Planning Commission

Revised Special Called Meeting Agenda

November 18, 2024 | 6:30 PM

SUBJECT: Building Elevations, Magnolia Dental, 100 Gates Entry

① EXTERIOR ELEVATION - SOUTH/ENTRY
1/8" = 1'-0"

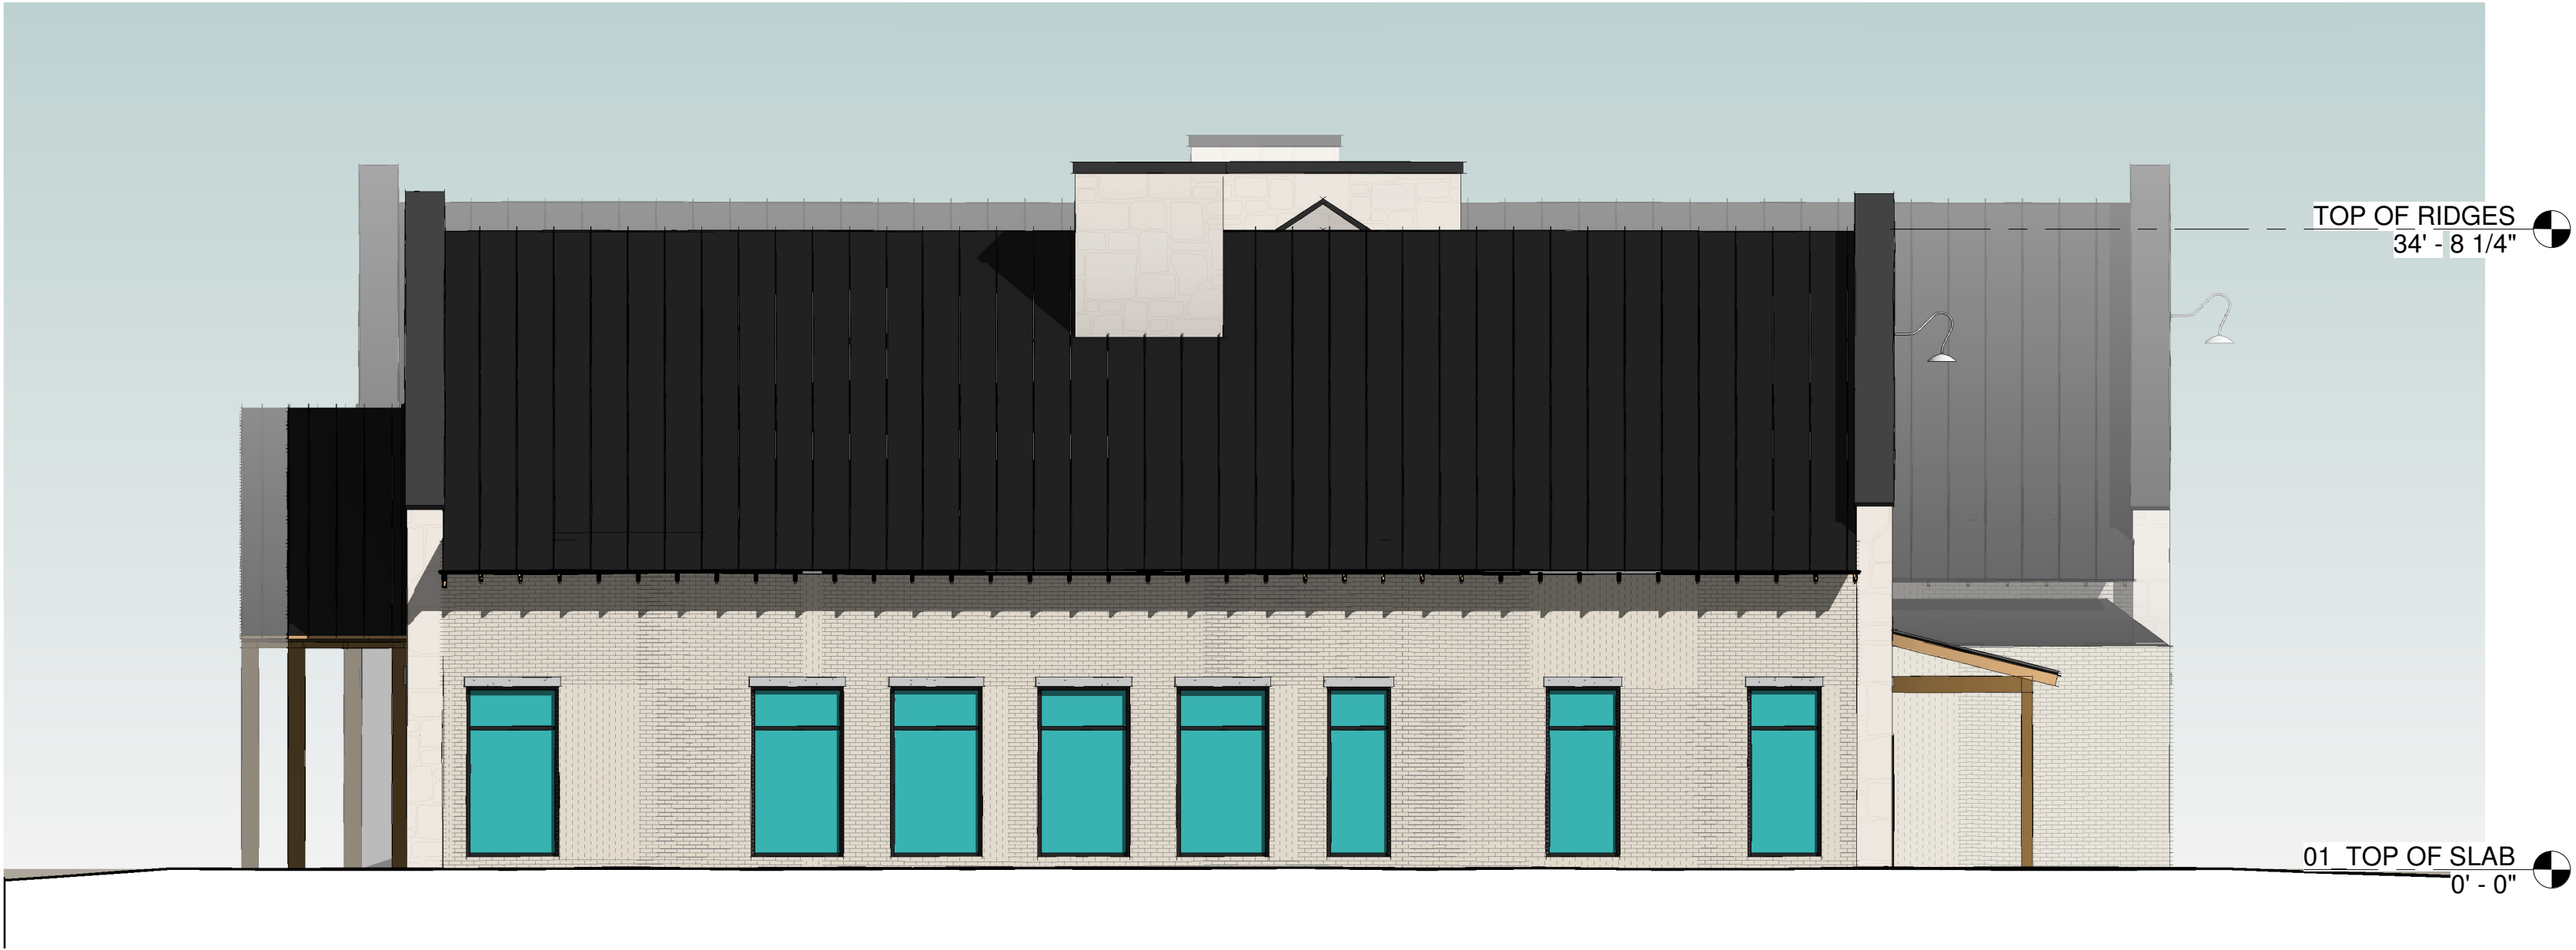
The building materials include stone and brick, which make up 100% of all facades. A charcoal colored metal roof is proposed as well as covered building entrances resembling front porches. The materials and architectural features contribute to the residential character of the design.

Staff believes the color palette is neutral, complementary to the homes in the subdivision, and compatible with the adjacent office building and thus meets the requirements of both the LDO and the zoning ordinance.
